MOORE SCHOOL OF ELECTRICAL ENGINEERING
UNIVERSITY OF PENNSYLVANIA

FUNCTION TAB & GATE CHASSIS D - PANEL 2

Drawn by MSP Date 5-5-1944 | Checked by RFT 12-Nov-44 | Approved by | Sheet 1 of 1 | PX-T-130

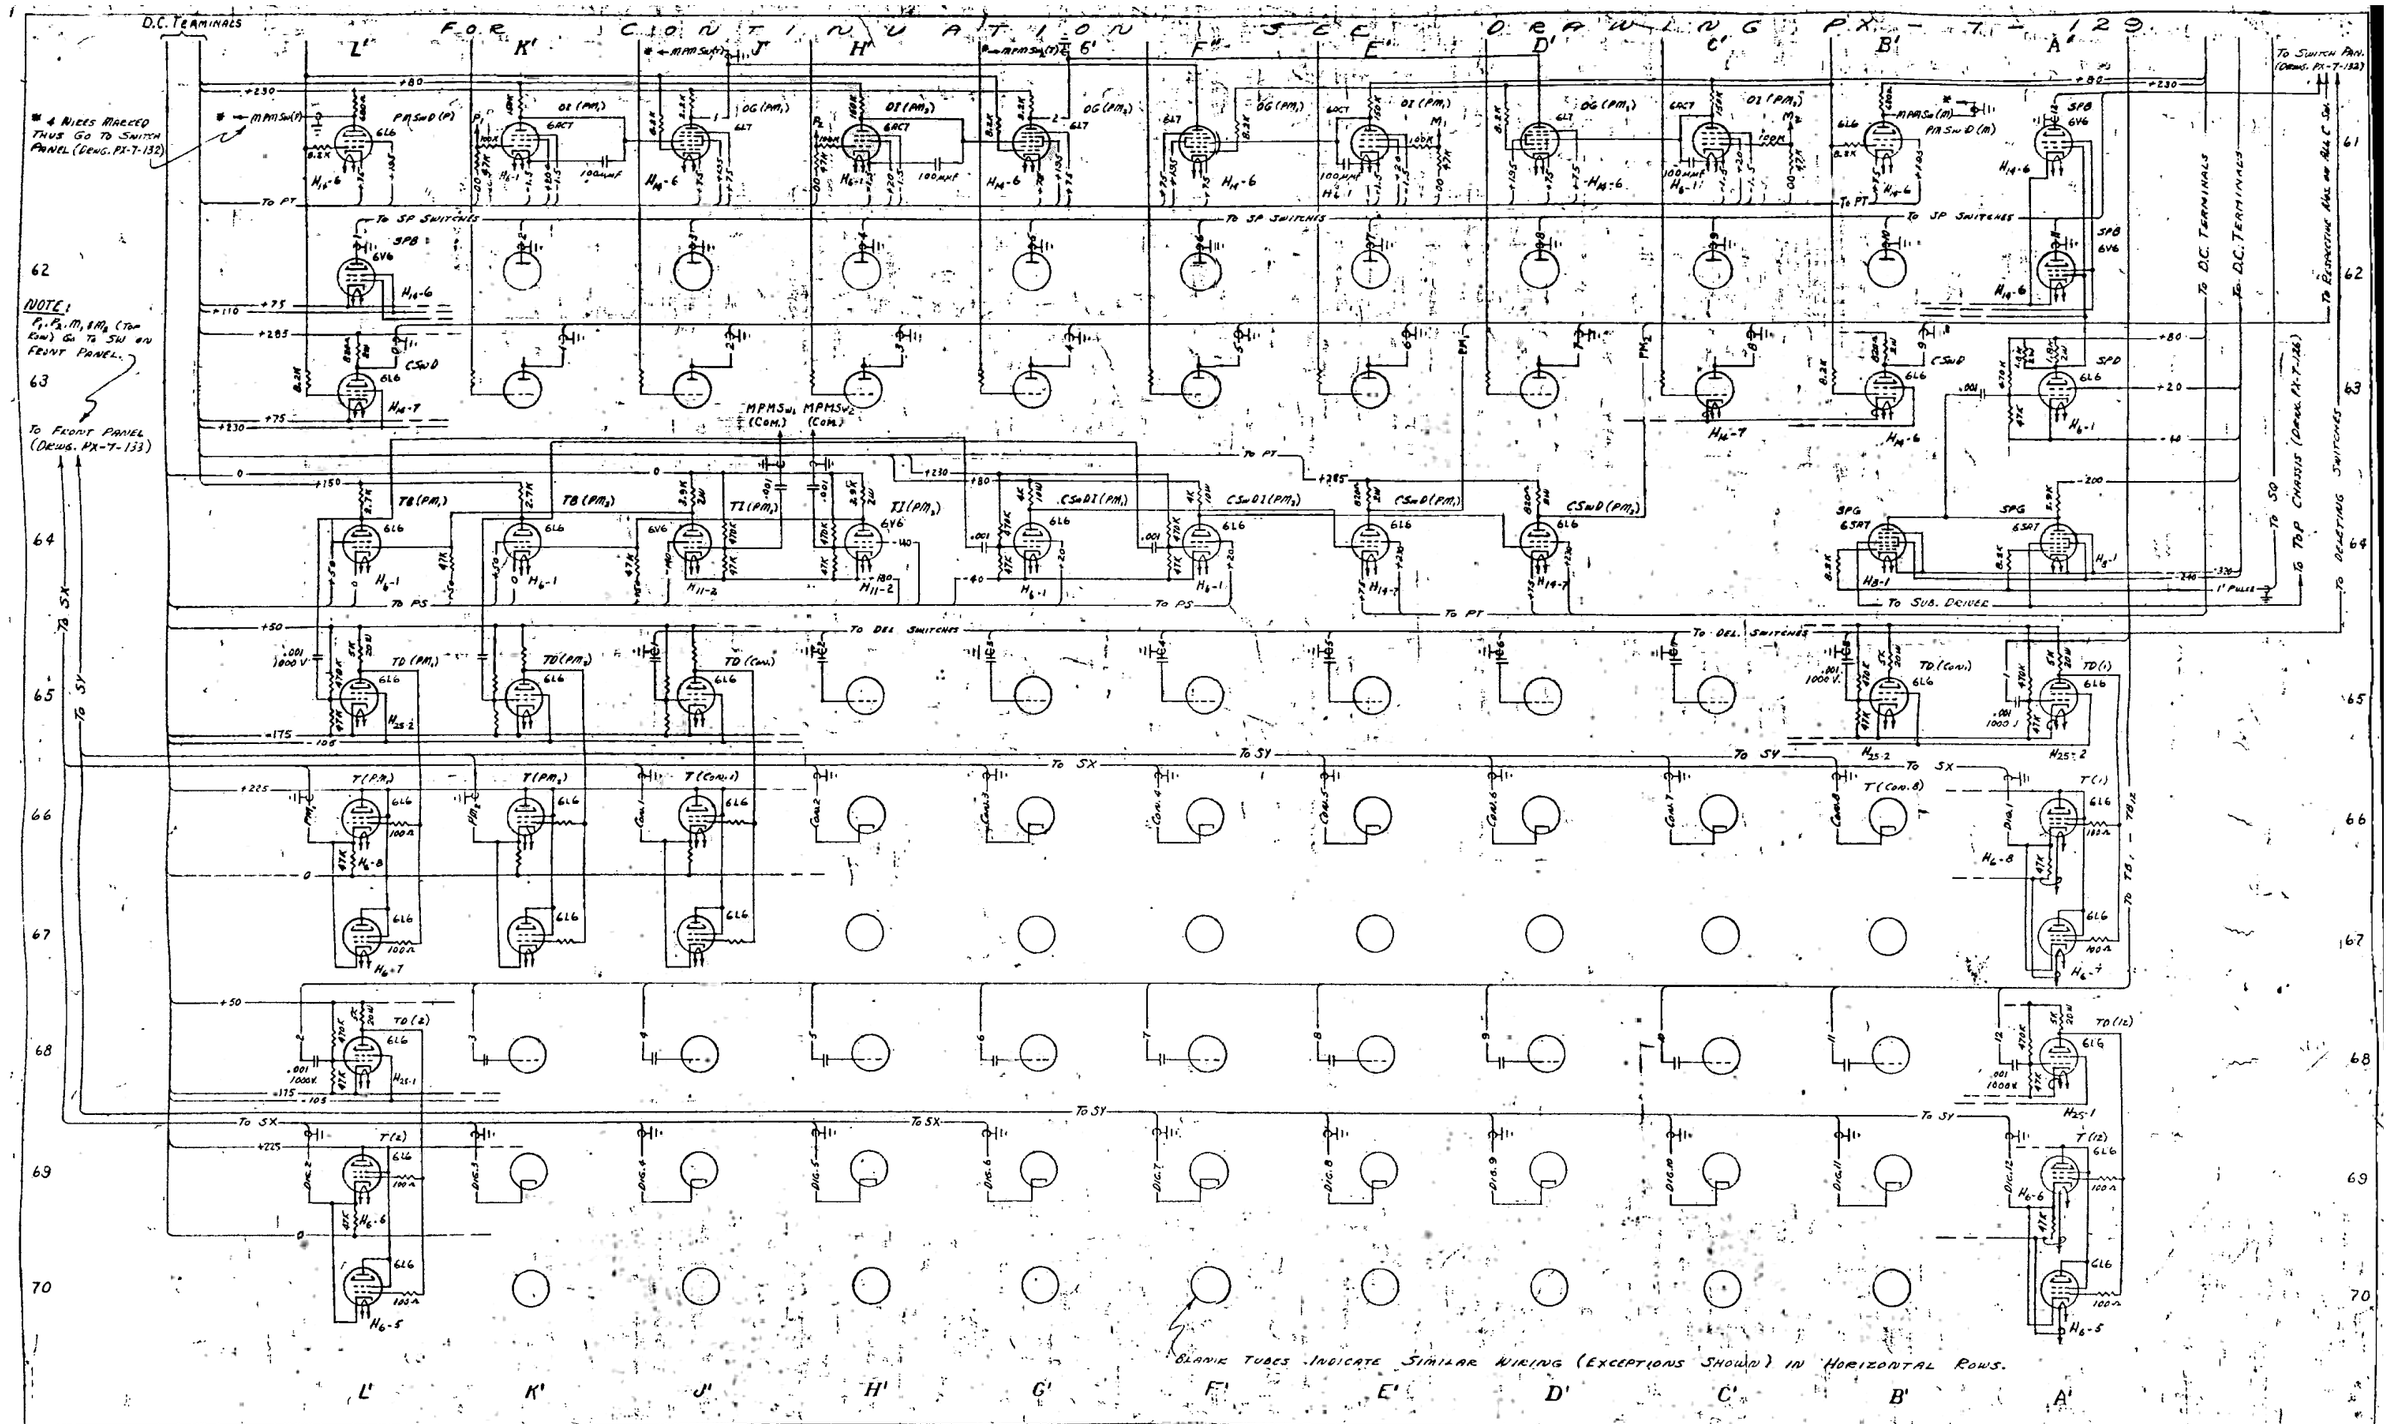
REVISIONS			
No.			
1	1st Final Revision	5-27-44	
2	2nd Final Revision	6-29-44	100K Grid Series Resistor Added To OT's. 100μμf Capacitor Added From Grid #3 To Cathode On OG's. OG Load Resistors Moved To Plate Side Of Pulse. 0.01μf Local Bi-Pass Capacitors Added From +230 To 0 At Each Row Of OG's. 220K Over-Drive Resistors On OT's Changed To 47K And 47K Grid Resistors Removed.
3		11-8-44
